P R O D U C T I O N M E M O

INSTRUMENT: 8566A SPECTRUM ANALYZER

SUBJECT: KEYBOARD SWITCH FAILURES
(FLYING SPRING SYNDROME)

Figure 1. Pushbutton Front-Panel Switch, HP P/N 5060-9436

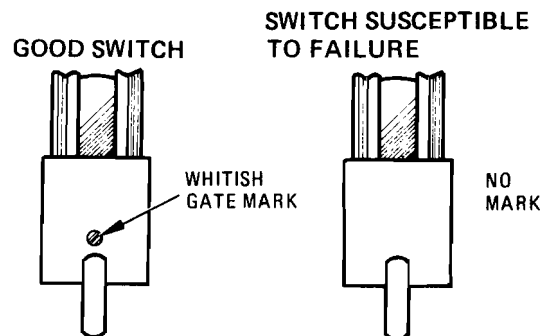
Not all switches are susceptible to the "fly-away spring" failure. Switches that have a "gate mark" (from the mold) that appears on the red body as a small whitish dot about in the center of the surface opposite the spring (see Figure 1) do not exhibit the "fly-away spring" failure.

8566A Spectrum Analyzers shipped after December 10, 1981 may have good switches that do not have a "gate mark". Therefore, the above criteria can be used to identify bad switches ONLY in 8566A Spectrum Analyzers that were shipped on or before December 10, 1981. (Serial Numbers 2115A00930 through 2140A01140 for the 85660A; 2112A02340 through 2134A02750 for the 85662A.)
